Access Compliance Report

Public Rights-of-Way

(Curb Ramps)

Intersection ID: 31585	Main Street: NAPTON_CT	Cross Street: PATTONSBURG_DR	Location: NE
ADA ID: 479C2778B19C	Ramp Type: PerpDiag	Initial Pass/Fail: Fail	Overall Compliance: No
Severity Score: 8.75			
Codes/Mitigation Info/Possible Solution		Field Measurements/Component Compliance

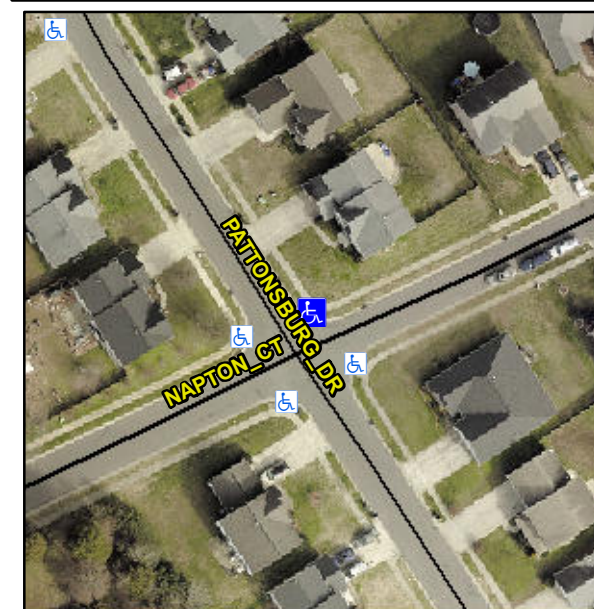
Not Found, R304.5.1

Remove & Replace Curb Ramp With Two New Directional Ramps or Equivalent.
